ERRATA

Case N-661-3
Alternative Requirements for Wall Thickness
Restoration of Class 2 and 3 Carbon Steel Piping for Raw
Water Service
Section XI, Division 1

Record No. 15-668

Case N-661-23

Figure 2
Overlay at Welding Neck Flange

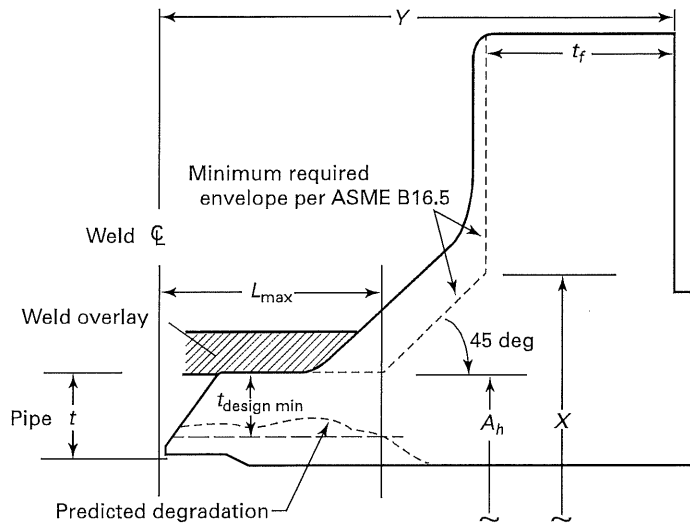
(f) Weld overlays on welding neck flanges shall be in accordance with Figure 2.

L_{max} = maximum length of corroded area with $t < t_{design\ min}$
 $= Y - t_f - (X - A_h)/2$

Figure 1
Overlay Configuration

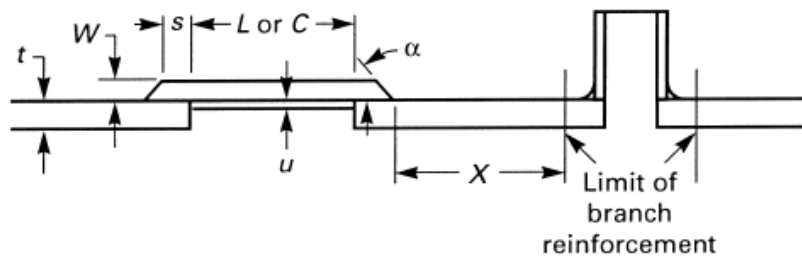
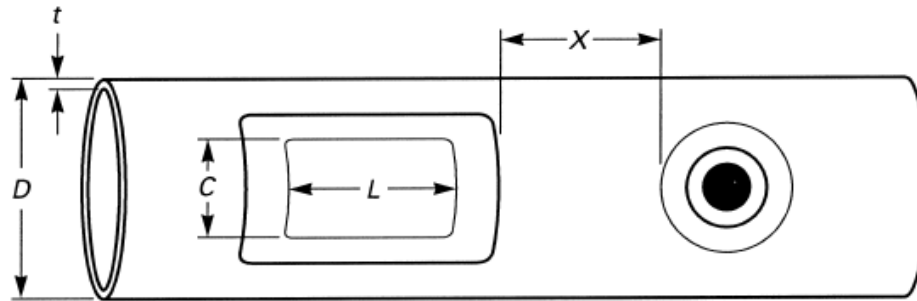
Edges of the weld overlay shall be tapered to the existing piping surface at a maximum angle (“ α ” in Figure 1) of 45 deg. Final configuration of the overlay shall permit the examinations and evaluations required herein, including any required preservice or inservice examinations of encompassed or adjacent welds.

Figure 2
Overlay at Welding Neck Flange

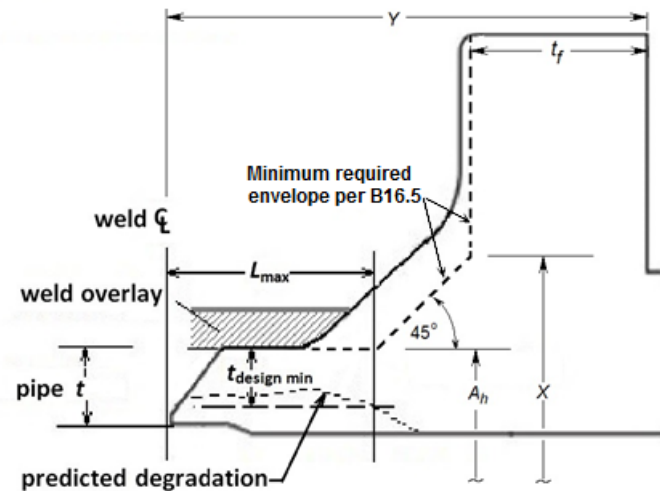
(2) The “s” dimension does not apply to portions of weld overlays extending in the axial direction to the reinforced area of welding neck flanges, as shown in Figure 2.

(f) Weld overlays on welding neck flanges shall be in accordance with Figure 2.

$$L_{\max} = \text{maximum length of corroded area with } t < t_{\text{design min}} \\ = Y - t_f - (X - A_h)/2$$
